### **3.8.3 Concrete and Steel Internal Structures of Concrete Containment**

MIC-04-03  
-0001

Figure 3.8.3-7 Typical Details of SC Modules (Sheet 1 of 5)

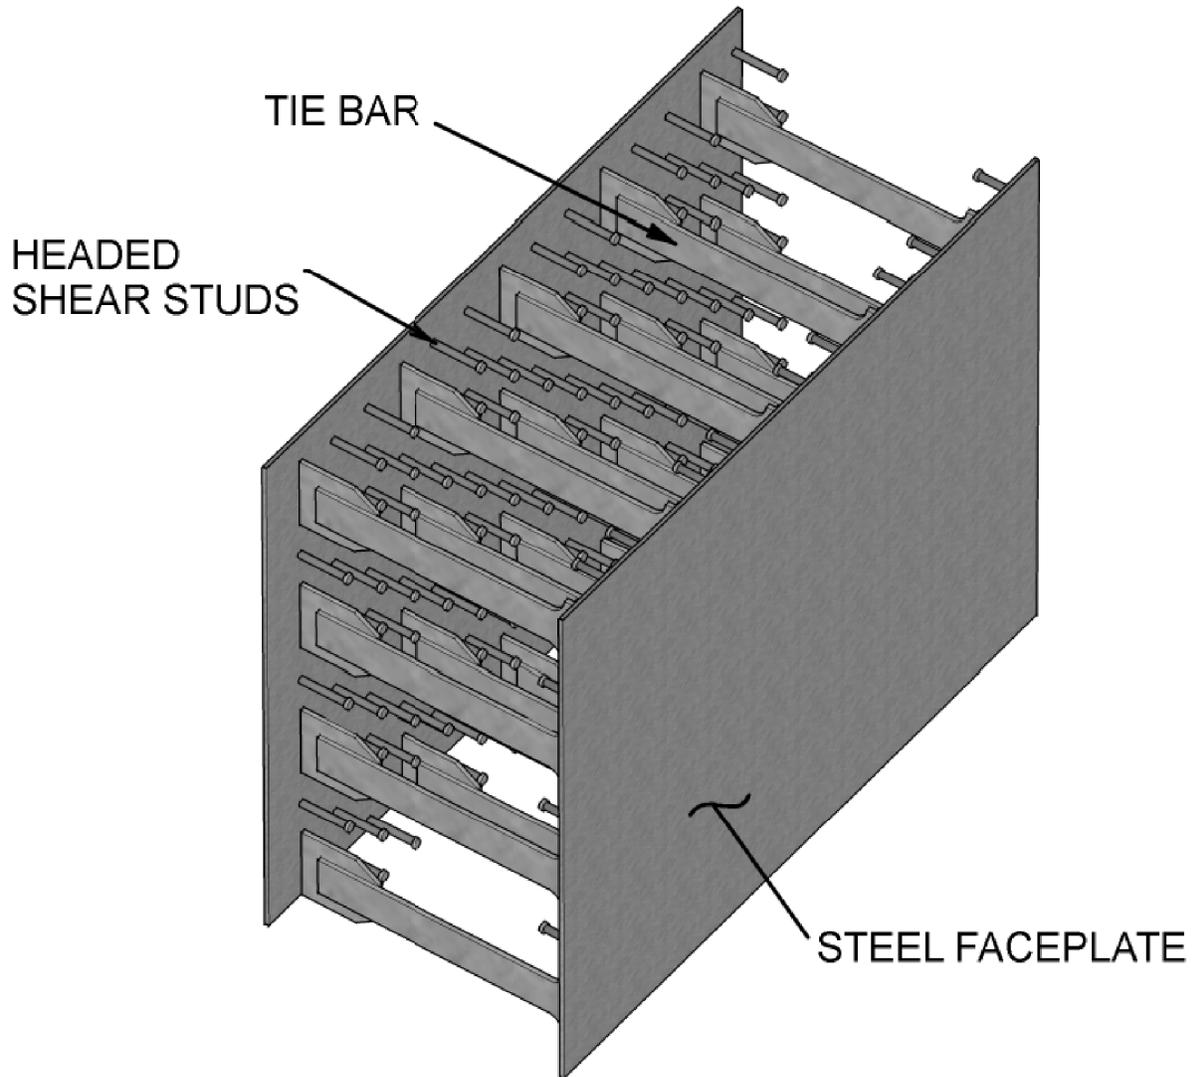
~~Figure 3.8.3-7~~ [Appendix 3L](#) shows the typical design details of the SC modules, typical anchorages of the SC modules to the reinforced concrete basemat, connections between adjacent walls, and connections between reinforced concrete slabs and SC walls. SC modules are designed using the methodology of reinforced concrete structures in accordance with ACI 349-06 (Reference 3.8-8), as supplemented in Technical Reports MUAP-11019 (Reference 3.8-71) and MUAP-11020 (Reference 3.8-72). The faceplates are considered as the reinforcing steel, bonded to the concrete by headed studs.

Figure 3.8.3-10 CIS FE Model

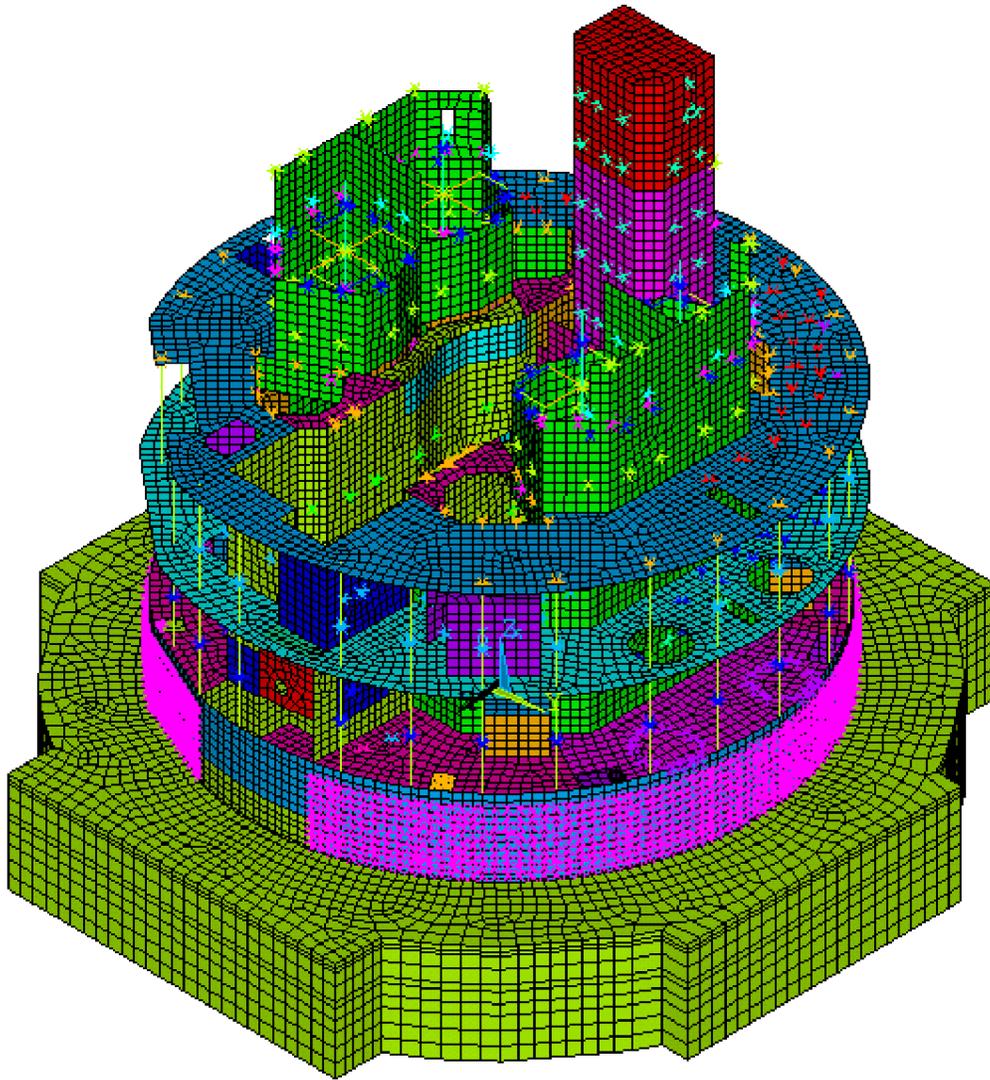
As shown in Figure 3.8.3-10, the Category 1 and 2 SC modules are simulated within the detailed FE model using ~~three-dimensional~~3-D shell elements. The Category 3 (primary shield) SC modules are modeled using ~~three-dimensional~~3-D solid elements. Equivalent elastic stiffness constants are computed for each of the SC walls, as well as the RC slabs, to achieve the stiffness terms identified for Conditions A and B summarized above in Subsection 3.8.3.4 and in Technical Report MUAP-11018 (Reference 3.8-70). The method of calculating the equivalent elastic constants is explained in Section 8.0 of Technical Report MUAP-11018.

Figure 3.8.3-11 ~~Deleted~~ **Critical Sections of SC Modules**

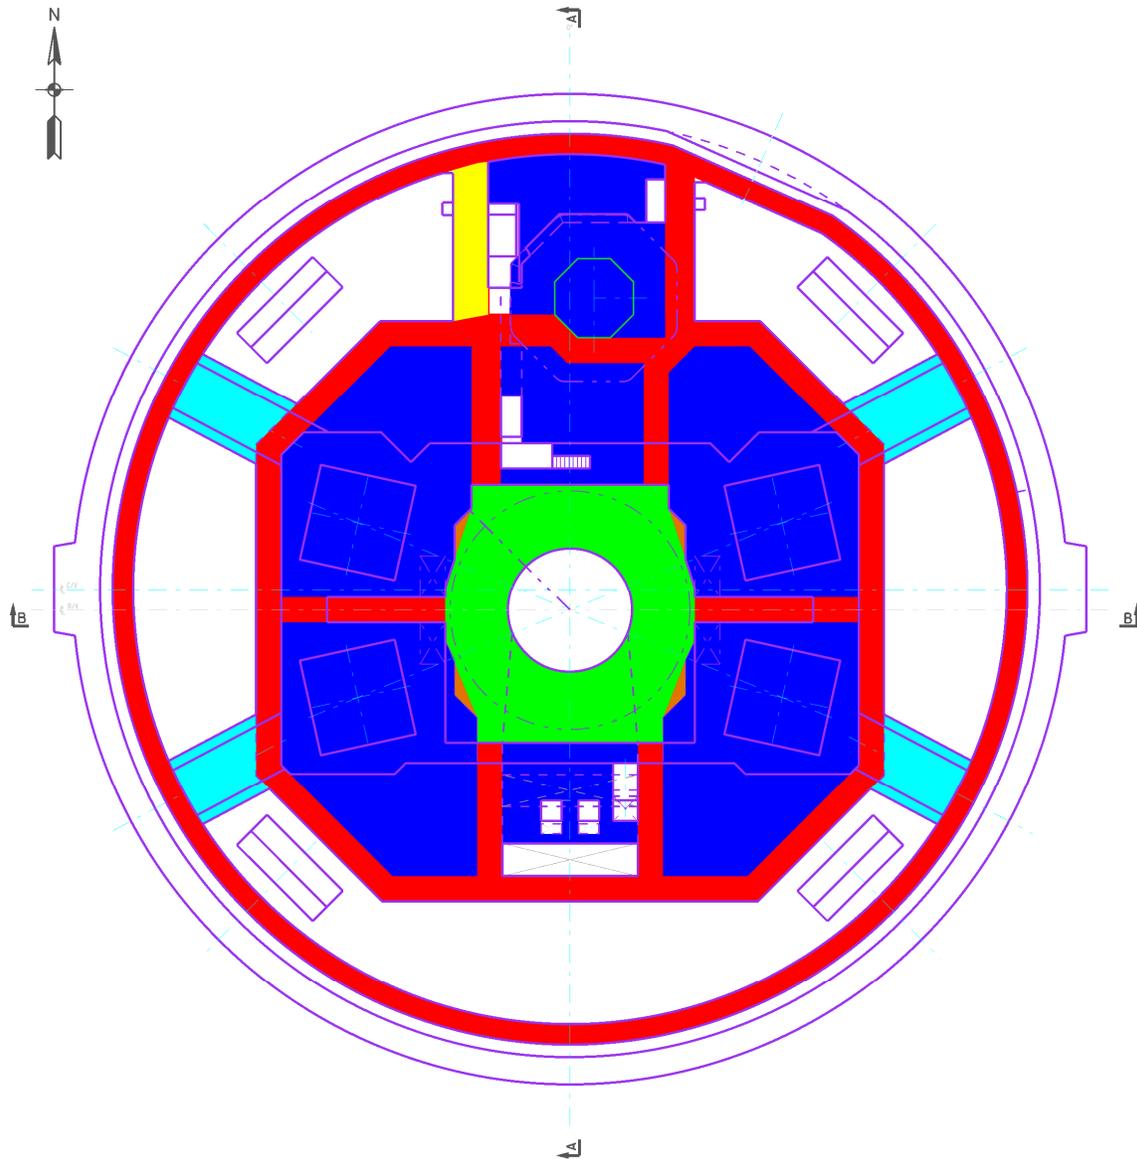
1. The applicable locations of each section are identified in ~~Figure 3.8.3-7 (Sht 2) and Figure 3.8.3-11 Appendix 3L.~~
2. The member thickness includes the steel face plates.
3. Connection Design Methodology refers to the Full Strength and Overstrength design approaches defined in Technical Report MUAP-11020 (Reference 3.8-72).
